Carolyn "Nicky" Ratliff
778 W. Watersville Rd.
Mount Airy, MD 21771

N
↑
Proposed
Cement Ratio
13' x 18'
w/ 30" Rebar

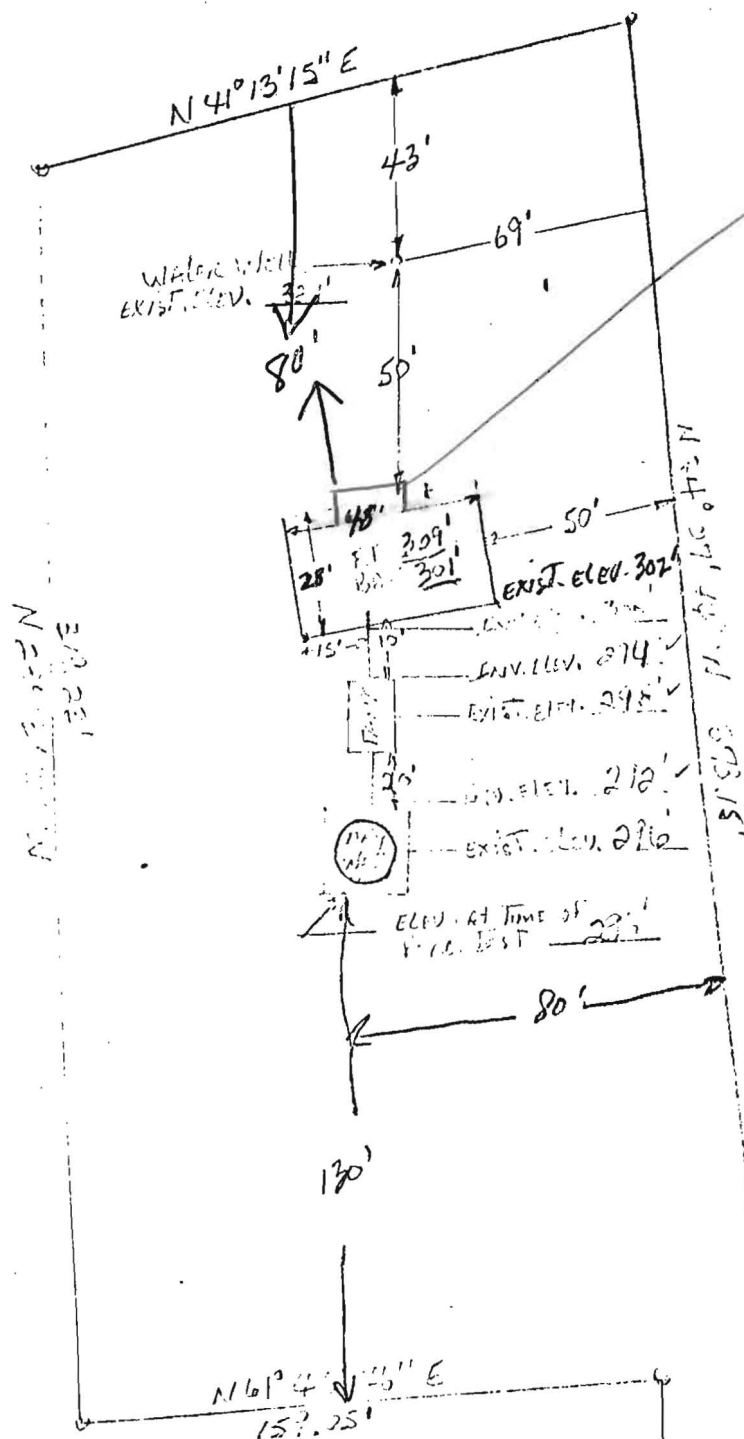
appears ok 5/21/76
C.B.S.

Get sliders in front starting 18" up or 50 to give more view out from Dining room?
